AGENDA

PLANNING AND ZONING COMMISSION

January 19, 2016 - Tuesday

**Figure 2
Removal Activity Map**

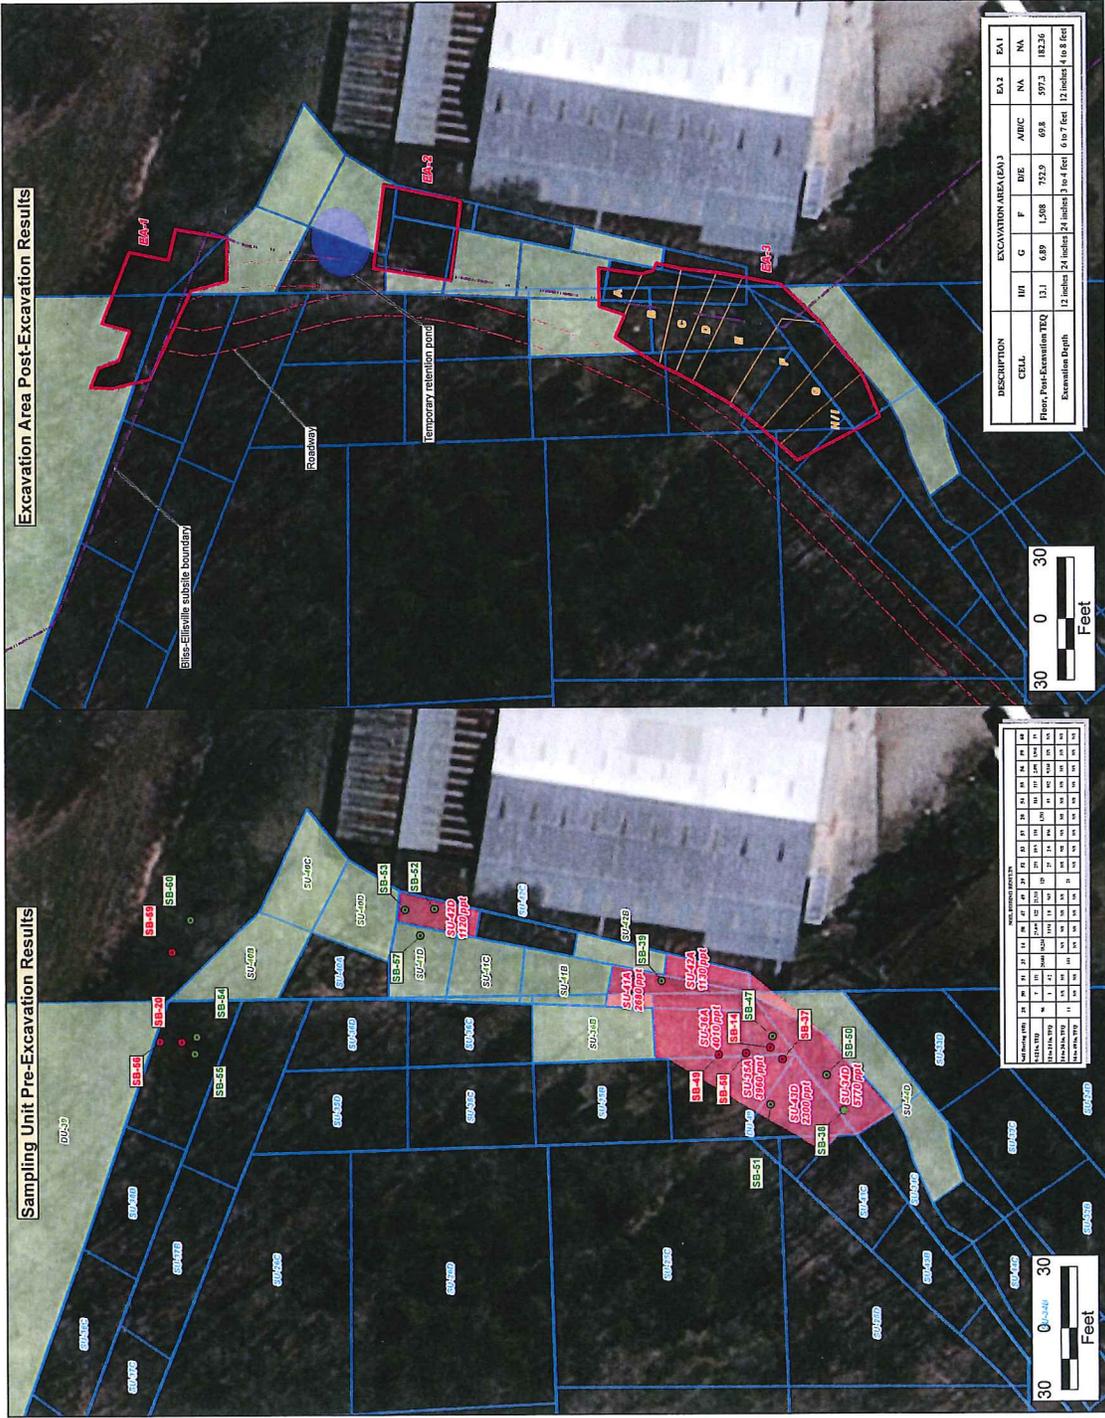
- g. Fig. 2 Pre-Excavation
 - i. Please add a triangle illustrating EA-1.
 - ii. Soil Boring table is illegible.
 - h. Fig. 2 Post-Excavation
 - i. Please illustrate NPL line in bright color.

- ii. Please add the 4 cell letters to EA-2.
 - iii. Please clarify EA-1 with Table 3 since it's an odd shape with 4 north walls.
 - i. Fig. 3
 - i. Please illustrate NPL line in bright color.
